Product Change Notification / SYST-09XAWH858

ERRATA - dsPIC33EPXXXGP50X, dsPIC33EPXXXMC20X/50X AND PIC24EPXXXGP/MC20X Errata Document Revision

dsPIC33EPXXXGP50X, dsPIC33EPXXXMC20X/50X and PIC24EPXXXGP/MC20X Family Silicon Errata and Data Sheet Clarification

FIGURE 1: TIMING DIAGRAMS FOR CENTER-ALIGNED AND EDGE-ALIGNED MODES

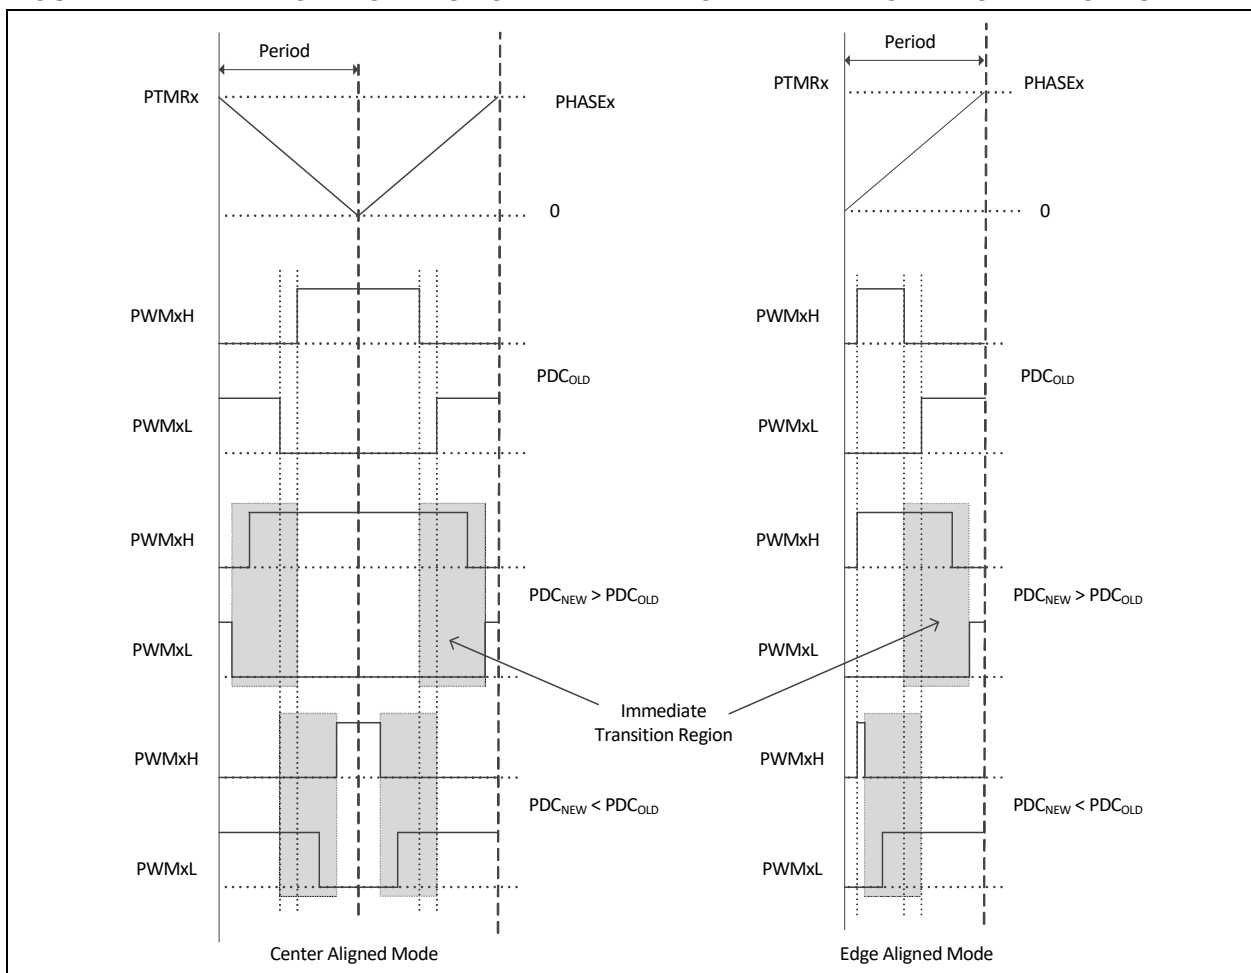
time base, will determine if the PWMxH and PWMxL outputs make an immediate transition. PWMxH and PWMxL outputs make an immediate transition if the Duty Cycle register is written with a new value, PDC_{NEW}, at a point of time when the PWM time base is counting a value that is between PDC_{NEW} and PDC_{OLD}. Additionally, writing to the Duty Cycle register, close to the instant of time where dead time is being applied, may result in a reduced dead time effective on the PWMxH and PWMxL transition edges.

In Figure 1, if the duty cycle write occurred in the shaded box, then PWMxH and PWMxL will make an immediate transition without dead time.

FIGURE 2: PWM TIMING DIAGRAM

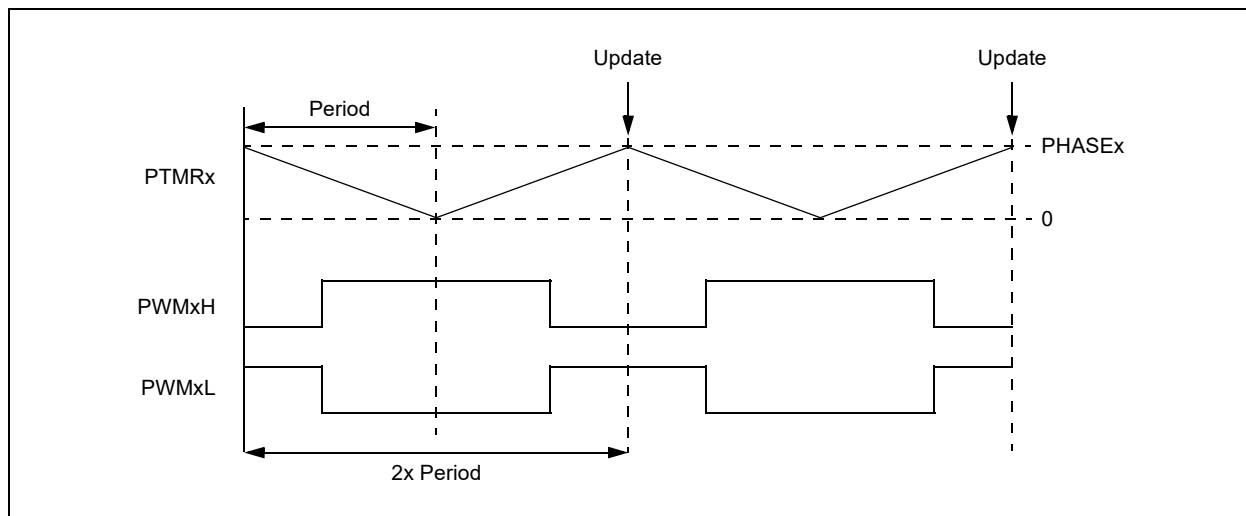
In Center-Aligned mode, updates to active MDC/PDCx/ALTDTRx/PHASEx registers occur only once every two PWM periods; that is, when the PWM timer matches the PHASEx register. In other words, the double update feature is not available. Figure 2 illustrates this relationship.

FIGURE 3: CORRECT AND INCORRECT POSITION COUNT CAPTURES

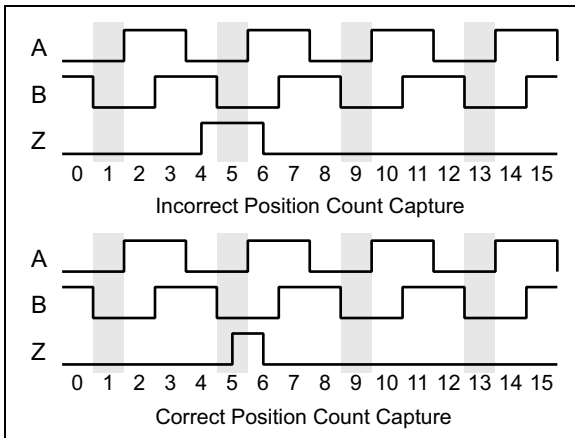
When index count position capture is being used (QEIXIOC.QCAPEN = 1), the position count may be one more or one less than the correct value, depending on the direction of the count.

This is only observed when the leading edge of the index pulse occurs prior to the leading edge of the index match event. When the index pulse starts after the leading edge of the index match event, the position count is captured correctly.

Figure 3 shows how this occurs. In these cases, Encoder Signals A, B and (index) Z are shown, with the module being configured for index match when A and B are '0'. The effects of a correct and incorrect capture are shown side by side (shaded area indicates the index match event); the position count is shown along the bottom.

For encoder signals with timing that ensures the index pulse always starts prior to the start of the index match event (i.e., encoders with a non-gated index pulse), measure the direction of the encoder motion. If the encoder is counting up, add one to the captured position count; if the encoder is counting down, subtract one from the captured position count.

For encoder signals where the index pulse leading edge approximately coincides with the start of the index match event (i.e., encoders with a gated index pulse), a small delay can be added to the index pulse, for instance, by using a simple R-C filter.

FIGURE 4: PWM GENERATOR TIMING DIAGRAM

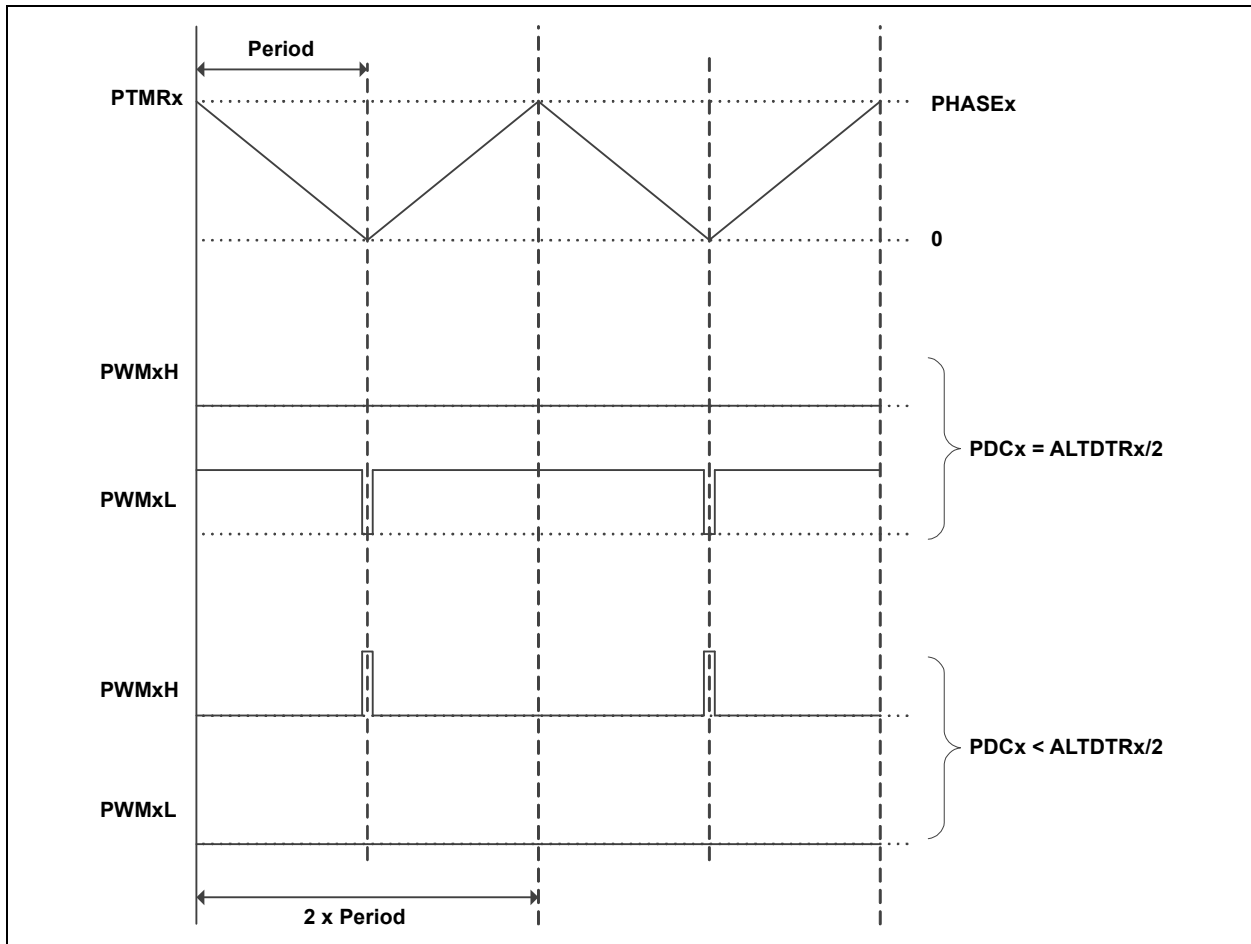
In Center-Aligned Complementary mode with Independent Time Base, if the value in the PDCx register is less than one-half the value in the ALTDTRx register, the PWM generator will force the PWMxL to low, and on the PWMxH, generate pulses of width less than twice the dead time, as shown in Figure 4.

FIGURE 5: ILLUSTRATION OF 1 T_{osc} GLITCH WHEN PWM OVERRIDE IS TURNED OFF

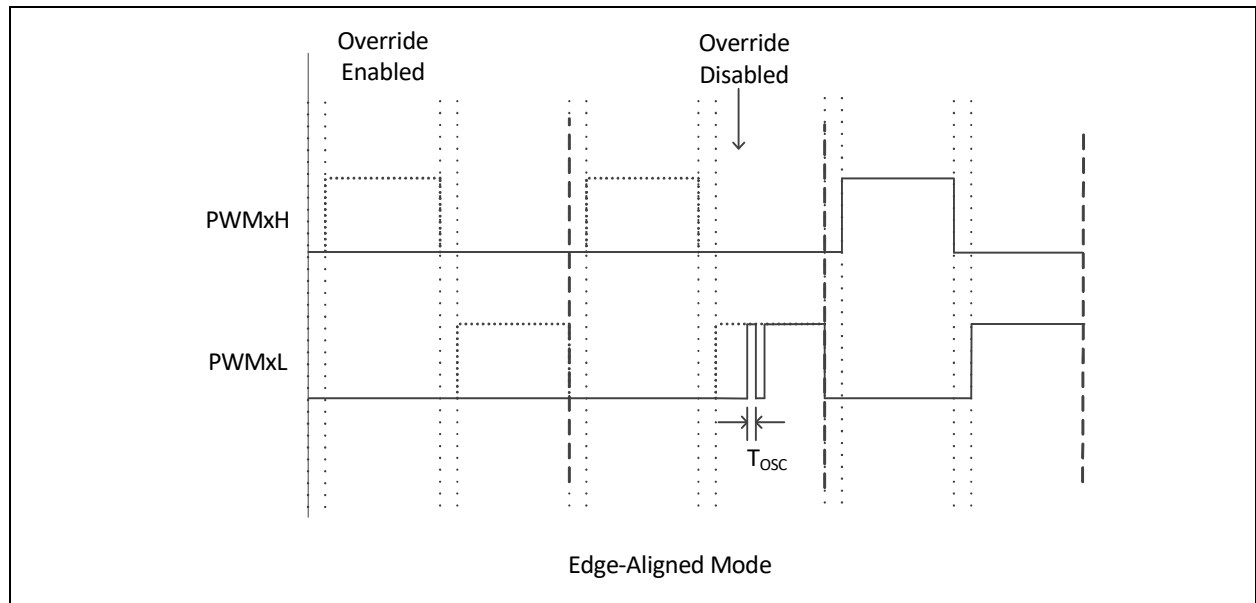
In Complementary mode after the PWMx module is enabled (PTEN = 1), if the PWM override is turned off, a 1 T_{osc} glitch will be present on the rising edge of either PWMxH or PWMxL, whichever occurs first, as shown in Figure 5. The glitch will be present on PWMxH/PWMxL every time the override state is changed from enabled to disabled. The width of this glitch is equal to 1 T_{osc} when PCLKDIV[2:0] = 000; increasing the PWM input clock prescaler setting will increase the width of the glitch accordingly.

FIGURE 6:

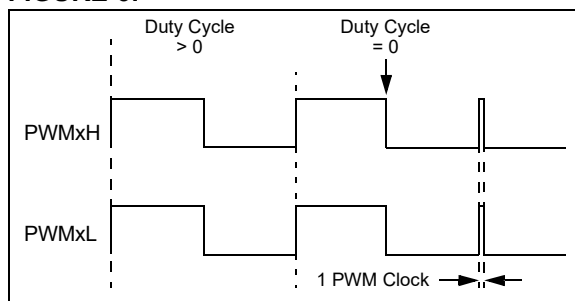
In certain output modes, the PWMx module produces a pulse glitch of one PWM clock in width (Figure 6). This has been observed only when all of the following are true:

- Either Redundant or Push-Pull Output mode is selected (IOCONx[11:10] = 10 or 01);
- Immediate Update is disabled (PWMCONx[0] = 0); and
- The value of the current Duty Cycle register (either the PDCx or MDC register, as determined by PWMCONx[8]) is updated to zero from any non-zero value.

The pulse glitch has been observed to occur at the beginning of the following PWM boundary period.

FIGURE 7:

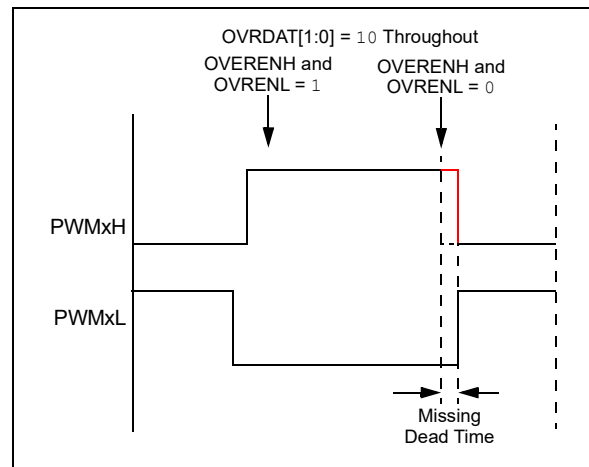
- Output override synchronization is configured to occur on the CPU clock boundary (IOCONx[0] = 0);
- Both PWMxH and PWMxL overrides are enabled prior to the event (OVRENH and OVRENL are both '1'), and
- Both overrides are disabled (OVRENH and OVRENL are both '0') at the instant the dead time should be asserted (Figure 7).

This has been observed in both Center-Aligned and Edge-Aligned modes.

FIGURE 8:

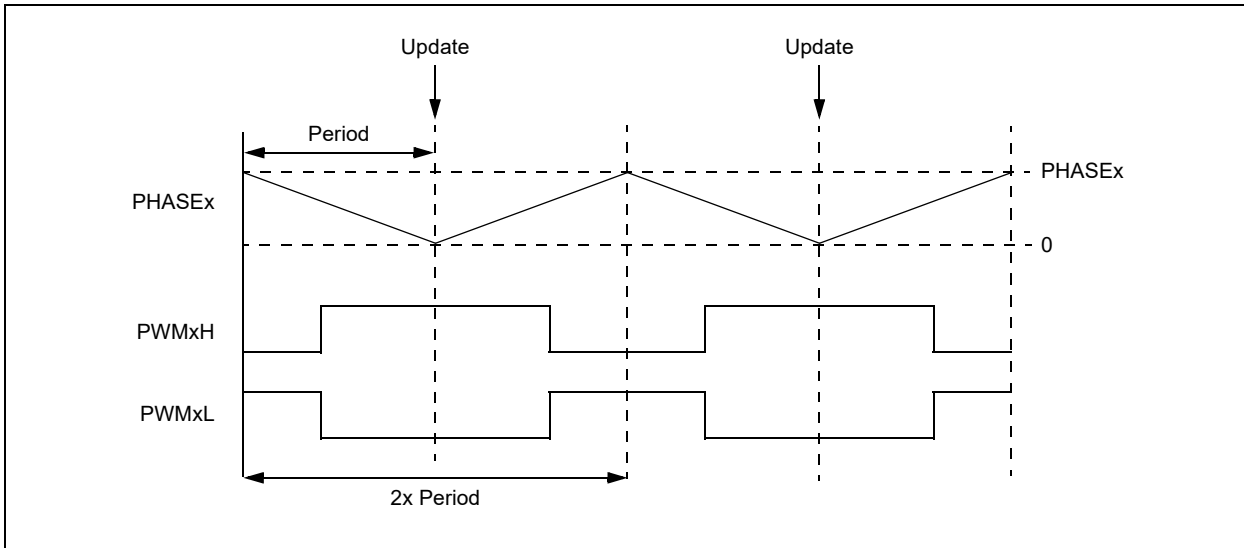
In Center-Aligned Complementary mode with Independent Time Base, updates to the PHASEx register take effect in the middle of a center-aligned PWM cycle, as shown in Figure 8. This occurs only when the Immediate Update feature is disabled (IUE = 0). If Immediate Update is enabled (IUE = 1), the PHASEx register updates will take effect immediately.

FIGURE 9: SIMPLIFIED BEHAVIOR

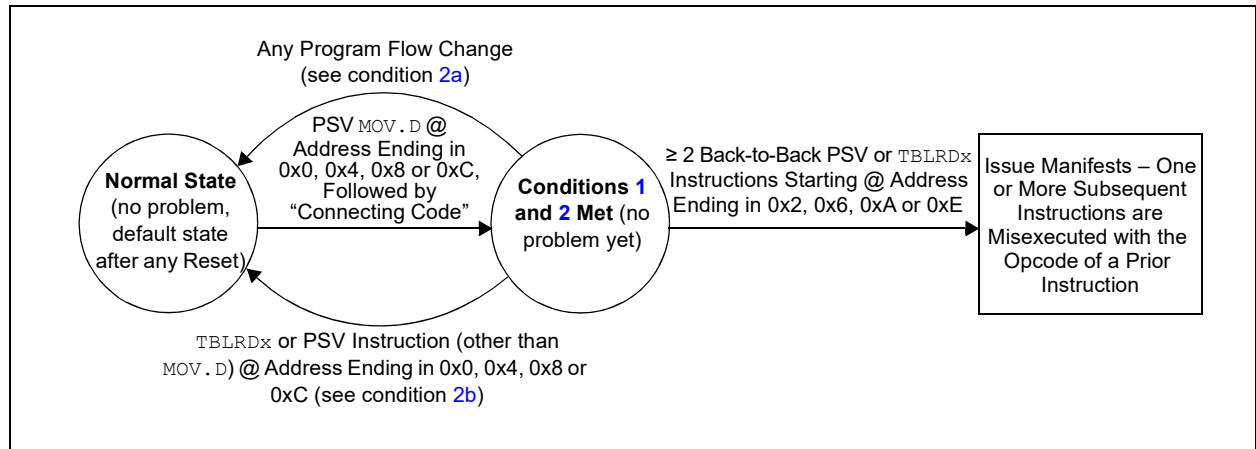
3.	≥ 2 back-to-back PSV or <code>TBLRDx</code> instructions are executed (following the code of condition 2), where the first of the back-to-back instructions is located at an address ending in 0x2, 0x6, 0xA or 0xE.

Figure 9 provides an example of the effective behavior.

1. All instances of PSV `MOV.D` can be replaced with two PSV `MOV` instructions instead. Non-PSV `MOV.D` instructions acting on RAM/SFRs do not need to be modified; or
2. If not already present, a program flow change instruction (such as `BRA $+2`) can be inserted above back-to-back data Flash read sequences; or
3. Back-to-back data Flash read instruction sequences can be broken up by inserting a non-Flash read instruction (such as a `NOB`) in between the Flash read instructions; or
4. The alignment of the code can be shifted to avoid the required opcode location addresses.

C code built with MPLAB® XC16 Compiler, Version 1.32, or later, implements the work around by default. However, if the application uses Assembly language routines, these should be manually modified to implement the work around. Additionally, if precompiled libraries are used, these should be built with XC16 Version 1.32 or later. For additional information, please visit: www.microchip.com/erratum_psrds_psrds.
